Re: Development near Montrose School

AMENITY LAYOUT PLAN, ROCKVILLE, MD

Project Plan No. 9-94003A

MONTROSE CROSSING, RMX-3C Zone

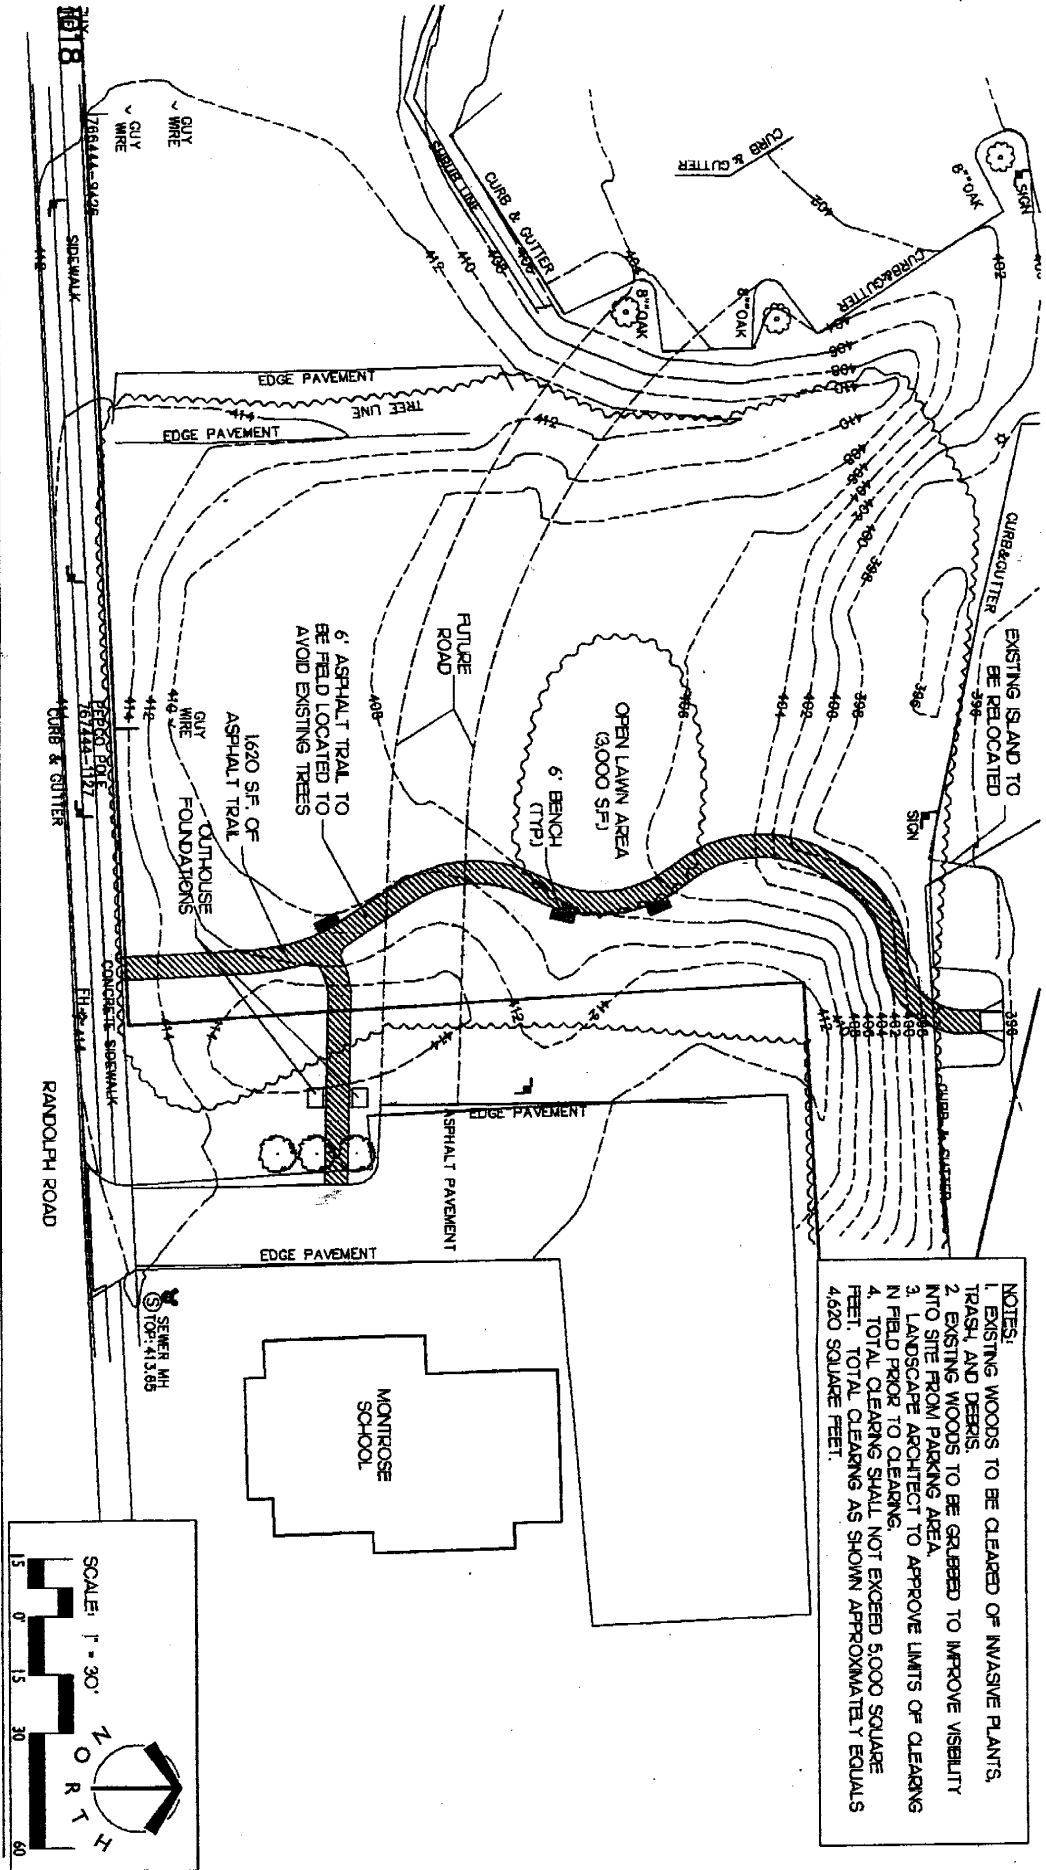
I met with Peter Melmed this fall to review his client's plan for the sidewalk, after which he revised it to reflect my suggestions. The attached plan now identifies the outhouse foundations and the three red cedars planted by students on Arbor Day 1924 to the west of the school. Mr. Melmed relocated the path to respect and include those features and added a bench facing toward the school building. With the clearing and grubbing of trash and invasive plants and perhaps the addition of a small interpretive marker, this will make an attractive and informative addition to our Master Plan site.

Highway Design has review the submission from Milestone Communities for their Montrose Crossing Phase III development. After talking with Greg Cooke, Engineering Access Permits, we both agree with the asphalt pedestrian trail from the proposed complex to the Montrose School.

However, we do suggest that as part of the lease agreement that Milestone fully understand that modifications will have to be made, in the future, to this trail to accommodate an entrance to the Montrose School facility as part of SHA's MD 355 project.

It is my understanding from Mr. Melmed that should the location of the future road into the school property (also shown on the map attached) change as those plans develop, that Peerless Rockville and the HPC would again be consulted if the subject sidewalk might also require reconfiguration.
